**PCN# 20121012003
UCC28XX device assembly - CMS C1209104
Final Change Notification**

PCN Number:	20121012003		PCN Date:	10/17/2012	
Title:	UCC28XX device assembly - CMS C1209104				
Customer Contact:	PCN_ww_admin_team@list.ti.com		Phone:	+1(214)480-6037	
Dept:	Quality Services				
Proposed 1st Ship Date:	04/17/2013		Estimated Sample Availability:	Upon request	
Change Type:					
<input checked="" type="checkbox"/> Assembly Site	<input type="checkbox"/>	Assembly Process		<input type="checkbox"/>	Assembly Materials
<input type="checkbox"/> Design	<input type="checkbox"/>	Electrical Specification		<input type="checkbox"/>	Mechanical Specification
<input type="checkbox"/> Test Site	<input type="checkbox"/>	Packing/Shipping/Labeling		<input type="checkbox"/>	Test Process
<input type="checkbox"/> Wafer Bump Site	<input type="checkbox"/>	Wafer Bump Material		<input type="checkbox"/>	Wafer Bump Process
<input type="checkbox"/> Wafer Fab Site	<input type="checkbox"/>	Wafer Fab Materials		<input type="checkbox"/>	Wafer Fab Process

Sample product shipping label (not actual product label)

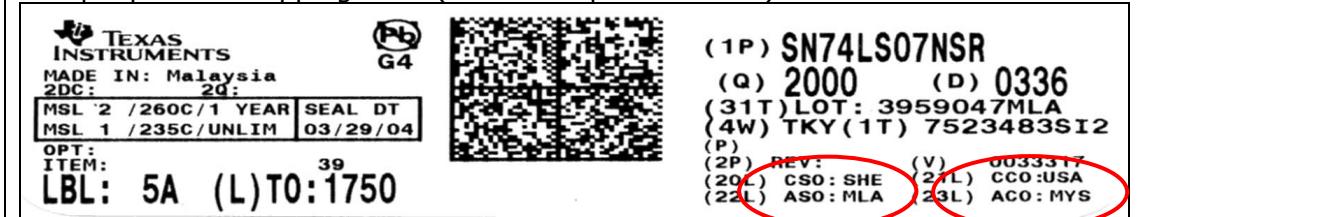
Changes to product identification resulting from this PCN:

Current:

Assembly site	Assembly site origin (22L)	Assembly country origin (23L)
MMT	ALP	USA

New:

Assembly site	Assembly site origin (22L)	Assembly country origin (23L)
TI Malaysia	MLA	MYS
